TECNO MOBILE LIMITED

Product Similarity Declaration

We, TECNO MOBILE LIMITED, hereby declare that we have a product named as Mobile Phone, Model: KH6, FCC ID: 2ADYY-KH6, has two versions, Hardware version: V1.0 and Hardware version: V1.2, the PCB of those two versions has partial minor circuitry of non-transmitter portions was difference, which were tested by Shenzhen Accurate Technology Co., Ltd., The differences between the two versions are as follows:

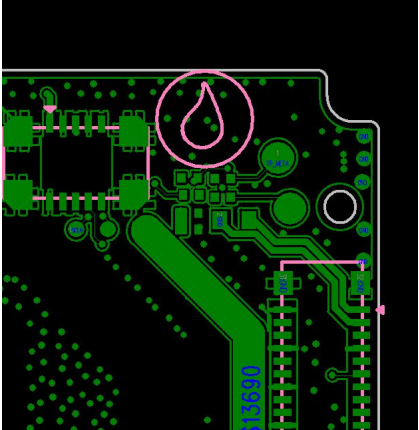
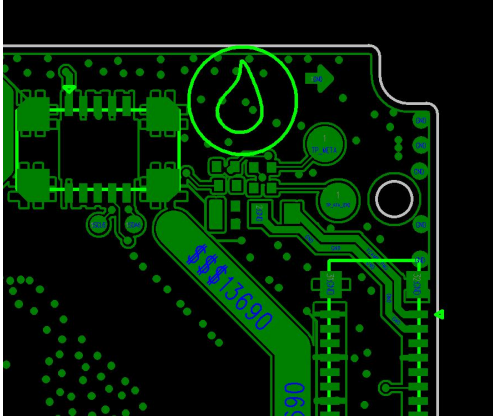
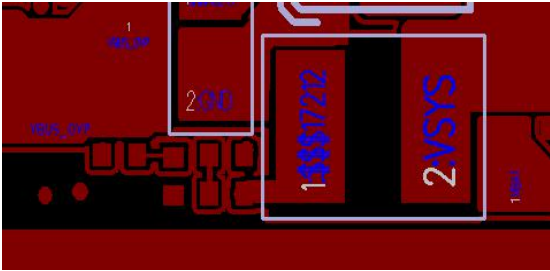
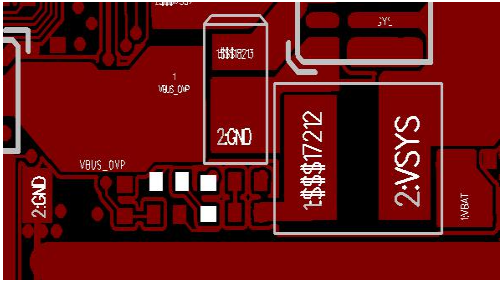
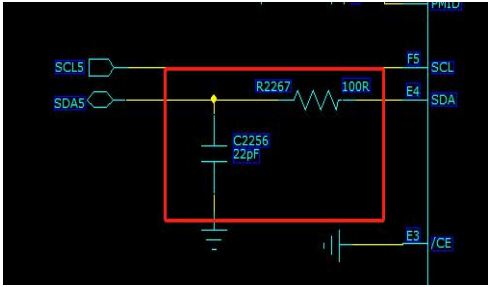
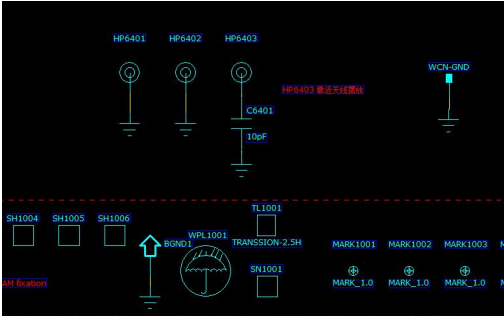
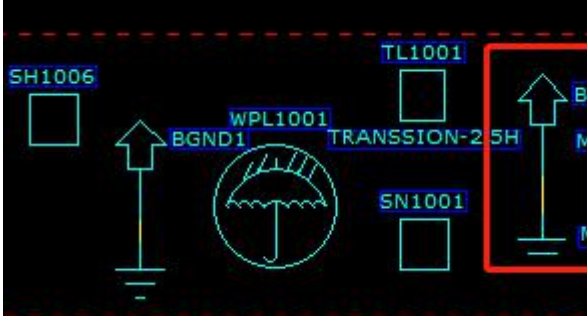
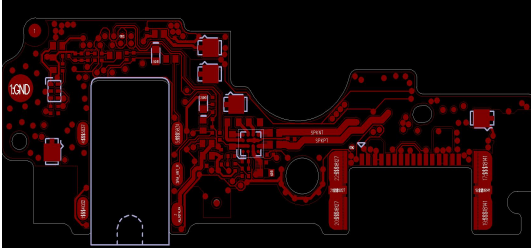
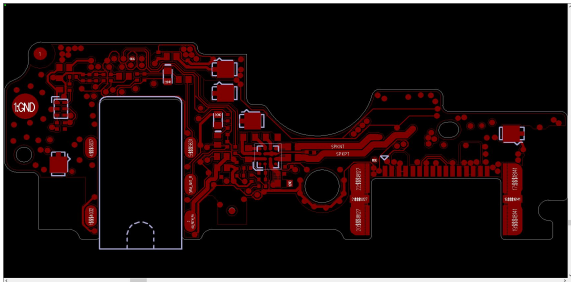
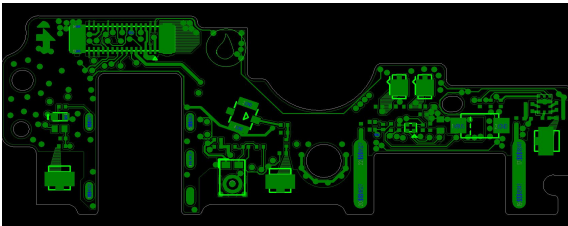
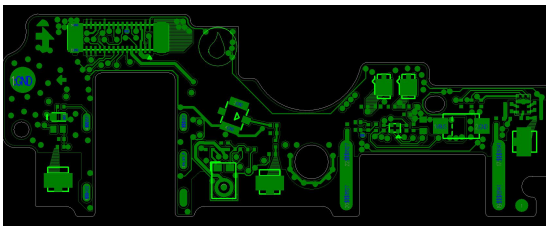
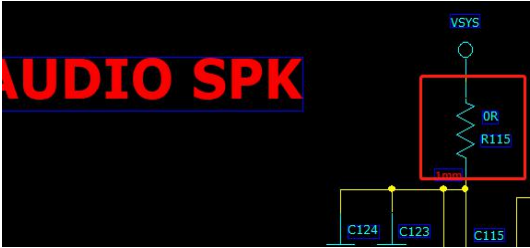
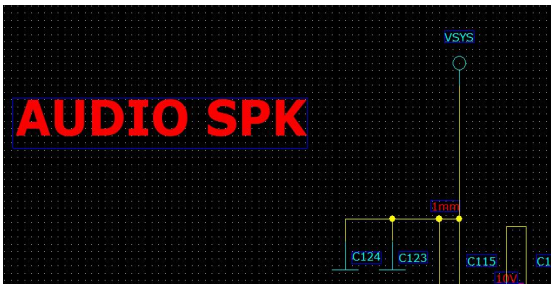
Hardware version	V1.0	V1.2
PCB change : Adjust the audio route to the board, and adjust the peripheral route		
PCB change : adjust optimization of linear

<p>PCB change :</p> <p>adjust isolate cabling and add the mainboard identifier</p>		
<p>PCB change :</p> <p>ADD R2267,C2256 and The wiring and component position are adjusted accordingly</p>		
<p>SCH change:</p> <p>Add R2267,C2256</p>		
<p>SCH change:</p> <p>Add BGND2</p>		
<p>PCB change :</p> <p>Change audio PA peripheral circuit placement and wiring, delete R115</p>

PCB change : Change MIC peripheral circuit placement and wiring ,and add TAG		
PCB change : delete R115		
PCB change : Add identifier
